HOPE CREEK GENERATING STATION  
DOCKET NO. 50-354  
FSAR COMMITMENT STATUS THROUGH AUGUST 1984

ATTACHMENT I  
HOPE CREEK GENERATING STATION  
FSAR COMMITMENT STATUS THROUGH AUGUST 1984

QUESTION 220.21 (SECTION 3.7.2)

FIGURE 220.21-10  
 RESPONSE SPECTRA COMPARISON,  
 UNIT 1 REACTOR BUILDING AT ELEV. 54' - 0",  
 E-W, OBE, 2% DAMPING

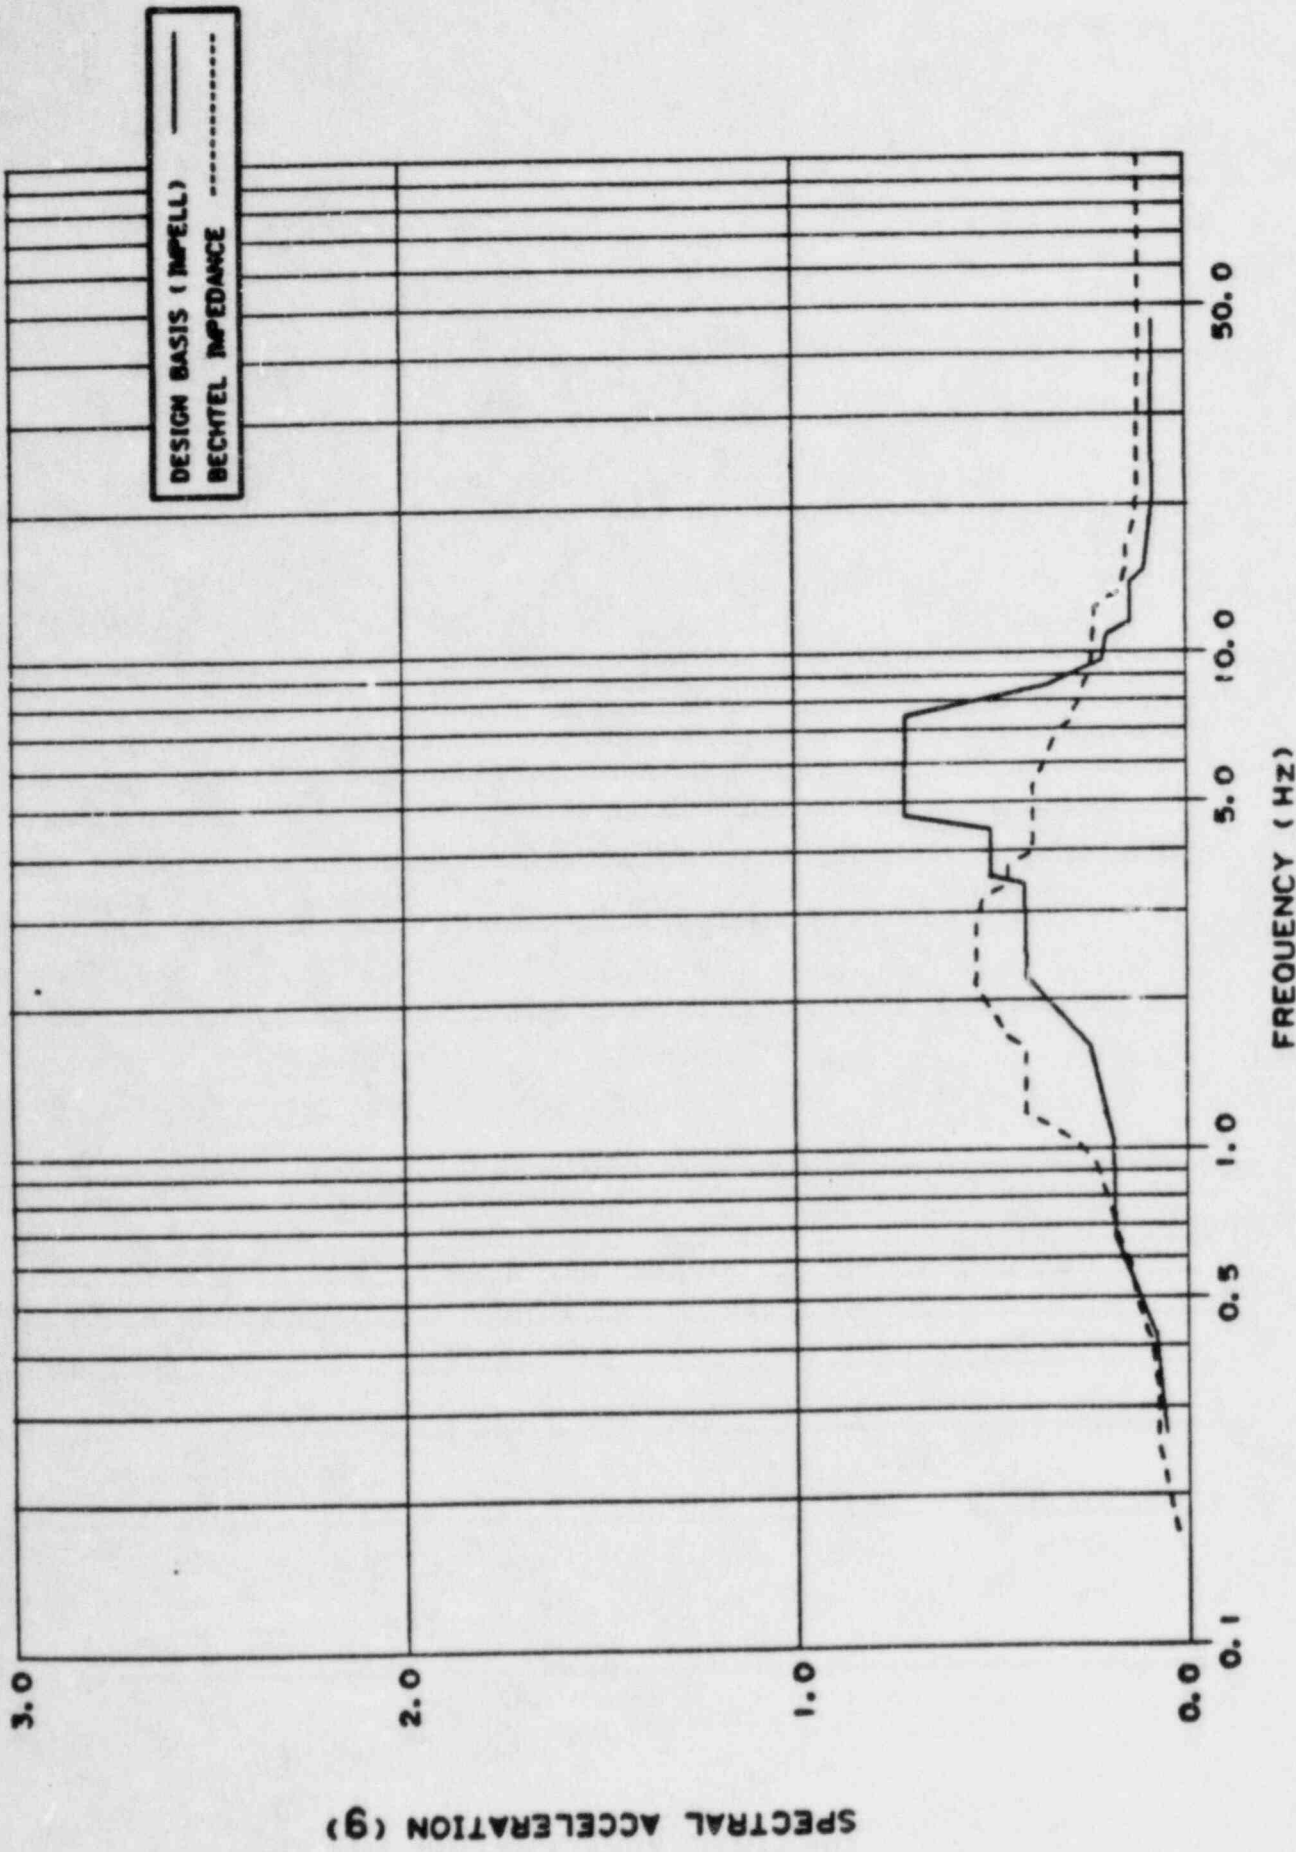
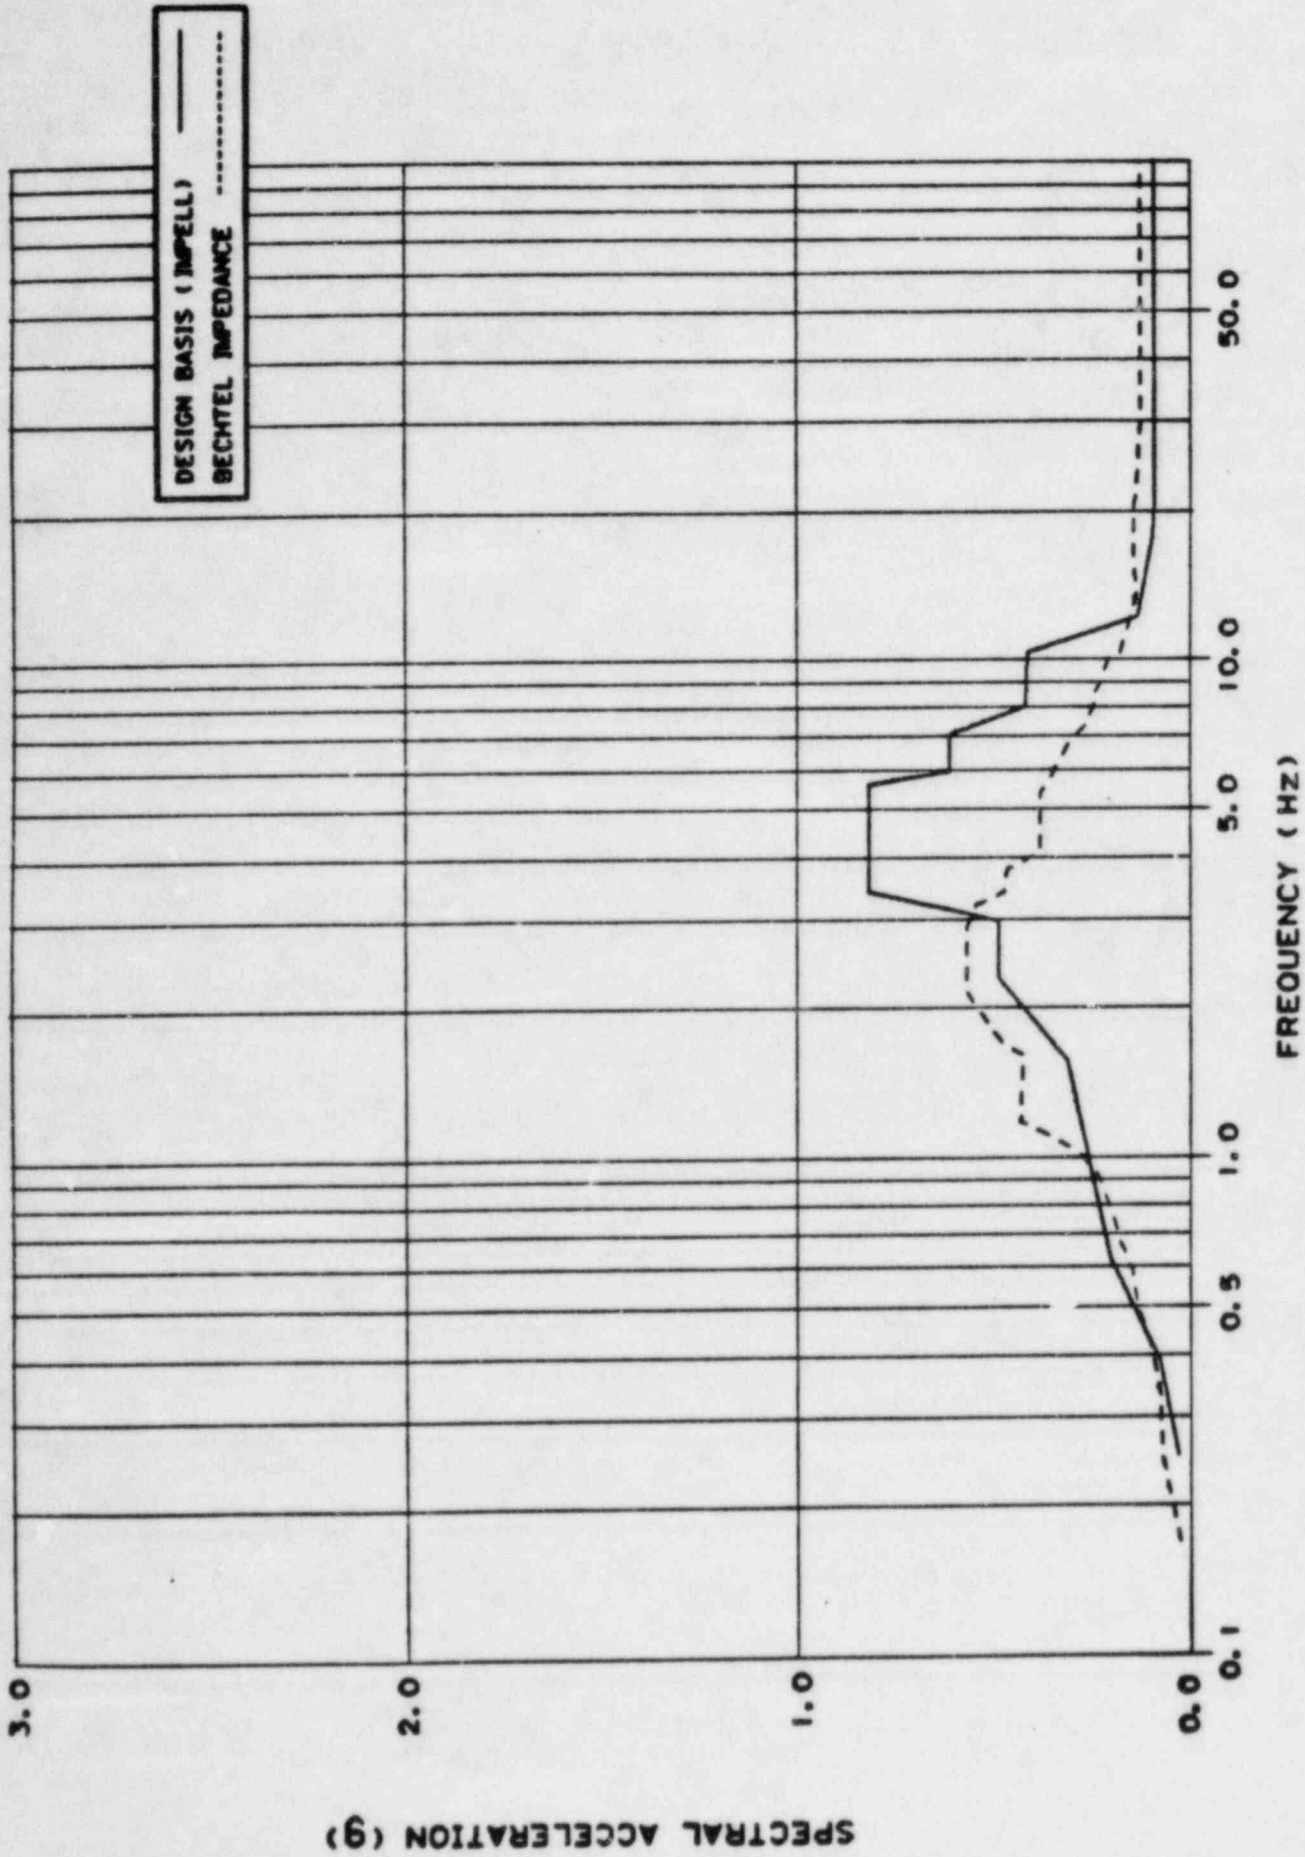
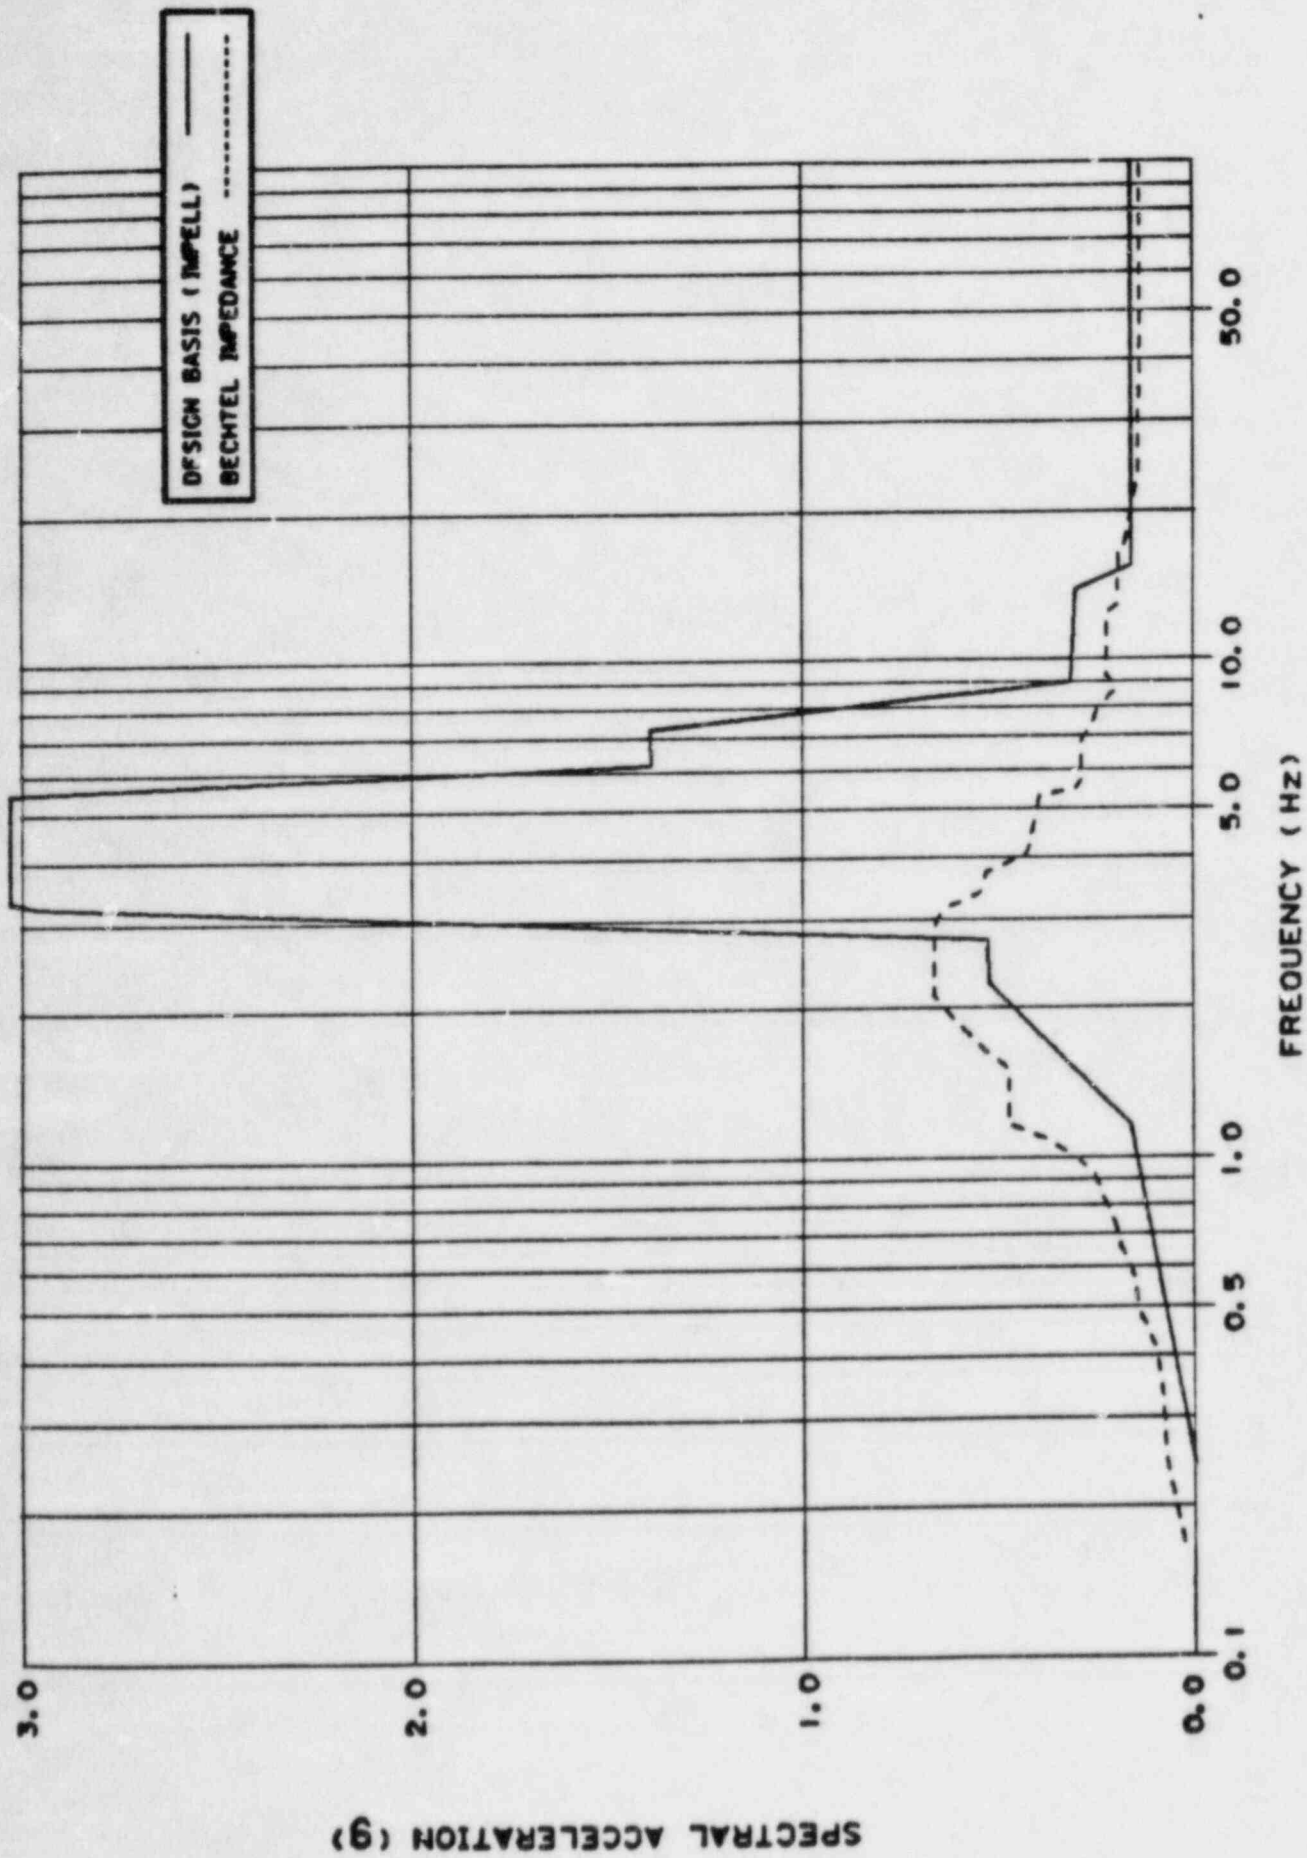
The Hope Creek soil-structure interaction analysis is performed by applying a specified earthquake input motion at the base of the finite-element model. The base level input motion is generated through a deconvolution analysis. The applicable SRP criteria for soil-structure interaction analysis require that both the half-space and finite-element approaches should be considered. (For details refer to SRP 3.7.2-11.4). Public Service should perform necessary analyses to demonstrate conformance to the criteria.

Figures 220.21-1 through 220.21-54 show a comparison of the 2 percent damping response spectra obtained from the design basis finite element and the impedance analyses for the reactor building, auxiliary building and the service water intake structure (SWIS).

¶ For the reactor and auxiliary buildings, the peak spectral accelerations obtained from the impedance analysis are generally lower than those obtained from the design basis analysis. However, the impedance analysis response spectra are not completely enveloped by those obtained from the design basis analysis, especially in the frequency range from 1.0 to 3.5 Hz. Also, there are some local exceedances in the higher frequency range, as shown in Figures 220.21-1 through 220.21-36. ¶ For the SWIS (Figures 220.21-37 through 220.21-54), the impedance analysis response spectra are generally enveloped by those obtained from the design basis analysis at elevation 114.0 feet. For other elevations, the impedance analysis spectral accelerations exceed the design basis spectral accelerations in some frequency ranges. These ranges vary approximately between 1.5 and 10.0 Hz.

forces and moments obtained from the impedance analysis exceeded the design basis values at various locations within these buildings. The auxiliary building seismic shear forces and moments obtained from the impedance analysis are less than the design basis shears and moments.

Since the impedance analysis results are not completely enveloped by the design basis finite element analysis results, sampling studies are conducted to confirm the adequacy of the plant design. These sampling studies include an evaluation of the following items:

In all cases, the items reviewed during these sampling studies can accommodate the loads resulting from the impedance analysis. Therefore, the impedance analysis results have no impact on the plant design.
